DEVIATION REQUEST AND DECISION FORM

Project Name :	Grandview Reserve Phase 1
Schedule No.(s) :	4200000396
Legal Description :	TR OF LAND BEING A POR OF THE S2 OF SEC 21, S2 SEC 22, N2 OF SEC 28 & 27-12-64 DESC AS FOLS;COM AT SE COR OF SD SEC 21, TH N 00<52'26" W ON THE E LN OF SD SEC 2645.09 FT TO THE NE COR OF THE SE4 OF SD SEC 21 FOR POB, TH N 89<41'03" E ON THE N LN OF THE S2 OF SD SEC 22 3938.18 FT, S 00<41'58" E ON THE E LN OF THE W2 OF THE SE4 OF SEC 22 2117.66 FT TO A PT ON THE NWLY R/W LN OF THE ROCK ISLAND REGIONAL TRAIL, ALG SD NWLY R/W LN S 45<55'49" W 758.36 FT TO A PT ON THE S LN OF THE SE4 OF SD SEC 22, N 89<38'06" E ON SD S LN 36.18 FT, S 45<55'49" W 3818.92 FT TO A PT ON THE N LN OF THE SW4 OF SD SEC 27, S 89<39'01" W ON SD N LN 36.17 FT, S 45<55'49" W 855.35 FT TO A PT ON THE ELY LN OF SD SEC 28, N 00<21'45" W ON THE E LN OF THE SE4 OF SD SEC 28 591.16 FT TO THE NE COR OF SD SE4, N 00<21'38" W ON THE E LN OF THE NE4 OF SD SEC 28 1319.24 FT TO THE S LN OF THE N2N2 OF SD SEC 28, N 89<47'08" W ON THE S LN 4692.55 FT TO A PT ON THE ELY R/W LN OF EASTONVILLE RD, ALG SD ELY R/W ALG ARC OF CUR TO THE L HAVING A RAD OF 1630.00 FT AN ARC DIST OF 697.73 FT A C/A OF 24<31'32

Exhibit 1

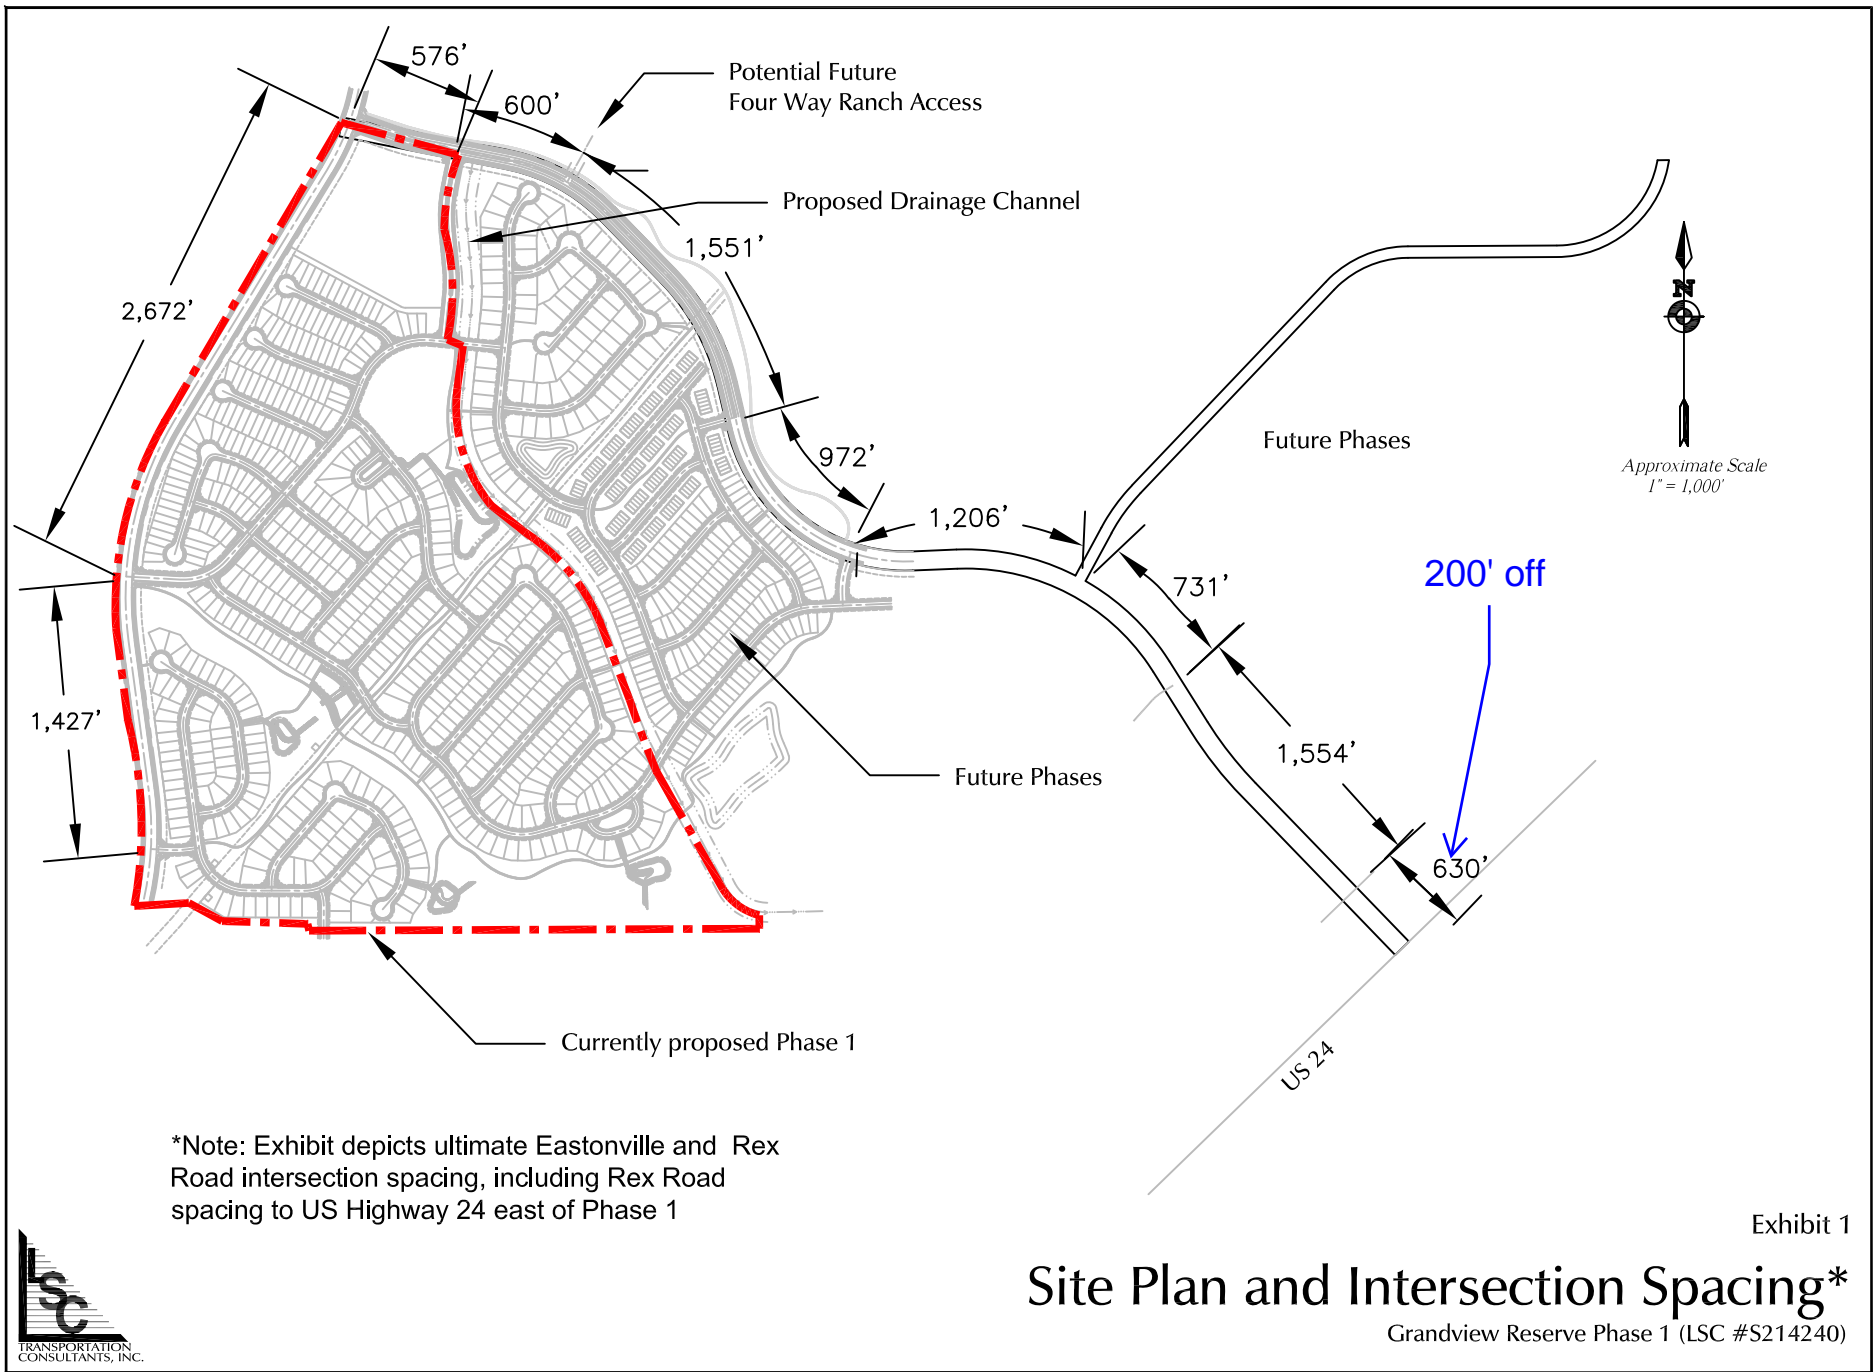
650' (minimum)
will be acceptable

Exhibit 3 Channel Alignment Constraint

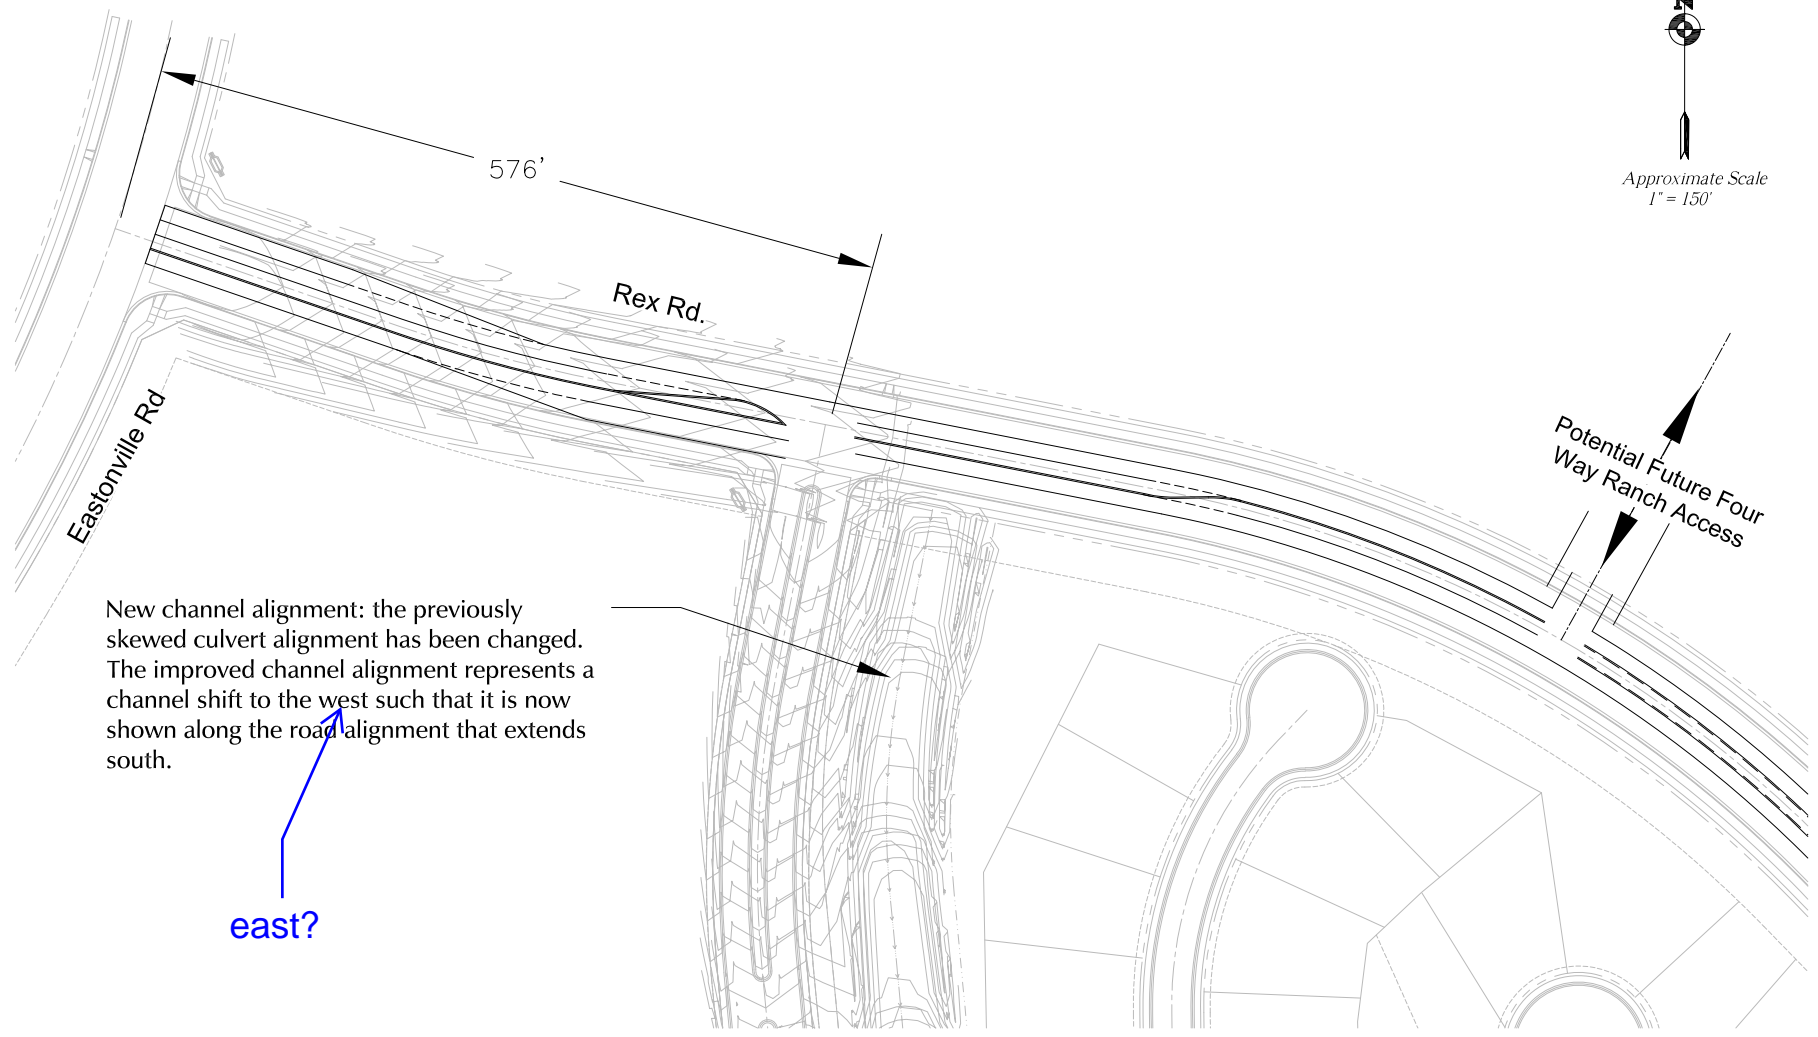
New channel alignment: the previously skewed culvert alignment has been changed. The improved channel alignment represents a channel shift to the west such that it is now shown along the road alignment that extends south.

east?

Exhibit 4 Potential Rex Rd. Lane Geometry

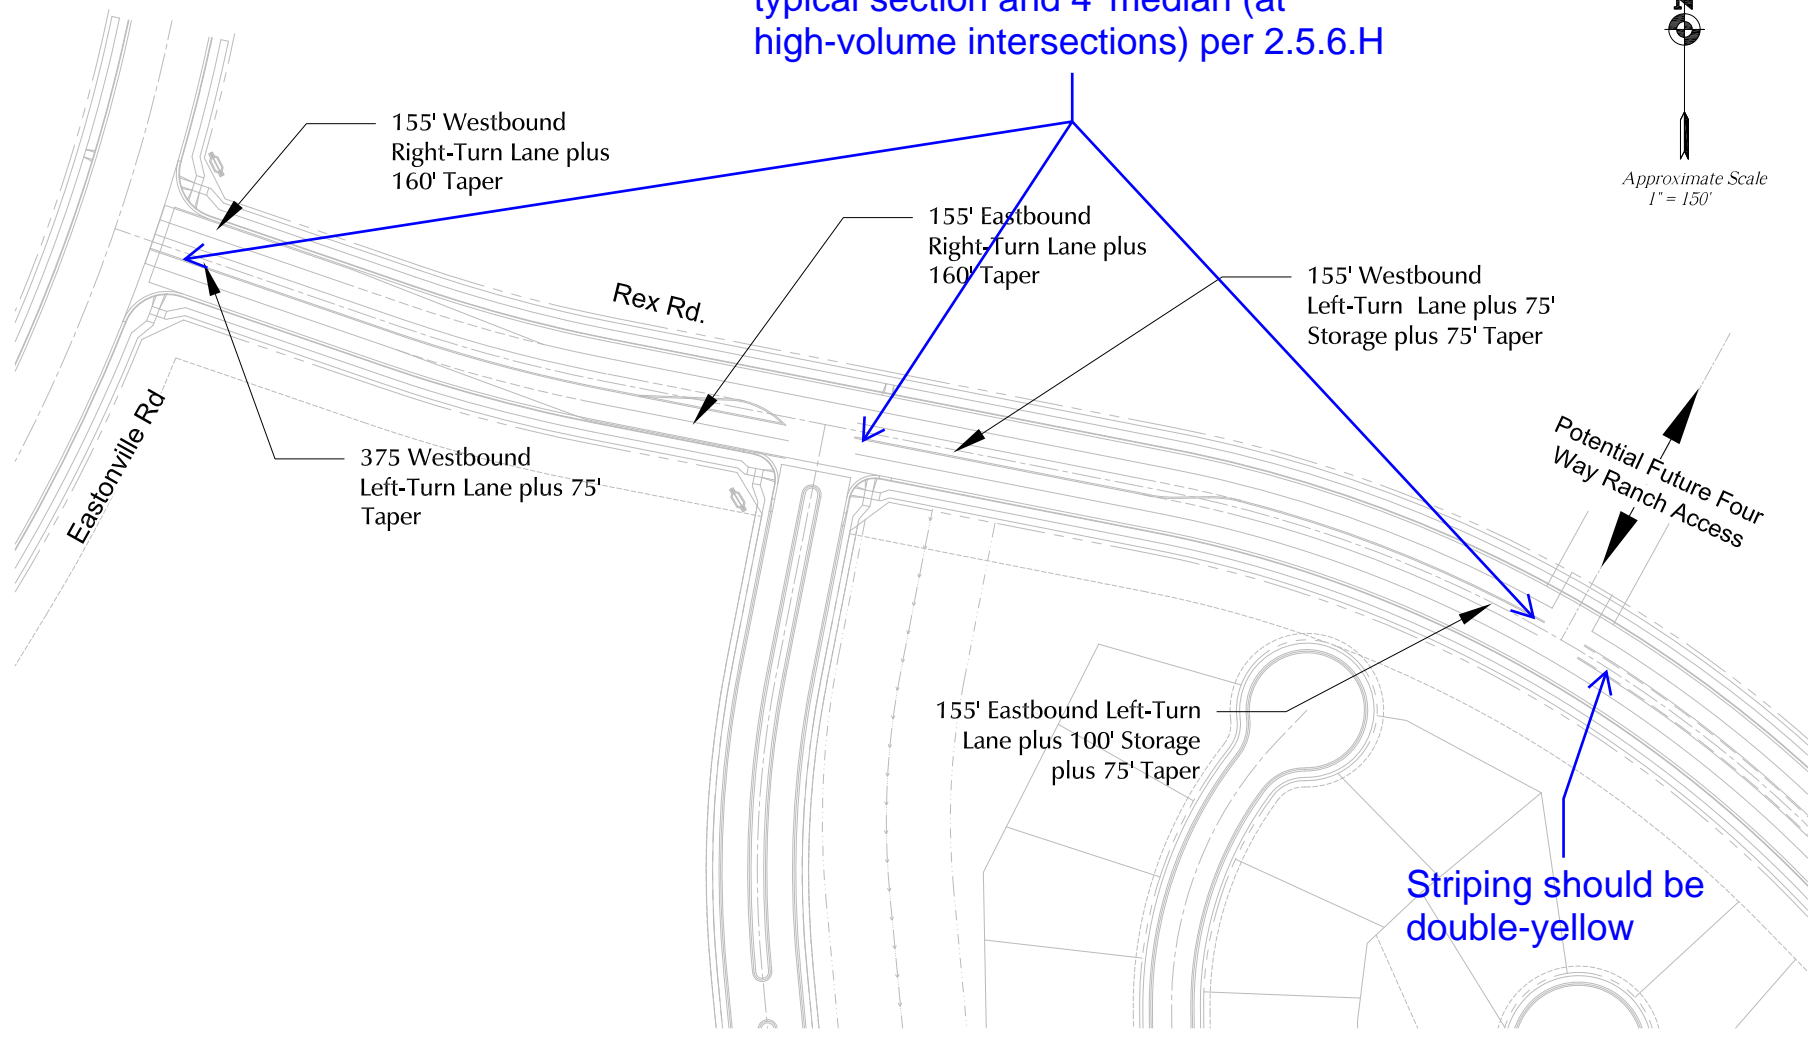
There should be a 14' turn lane per typical section and 4' median (at high-volume intersections) per 2.5.6.H
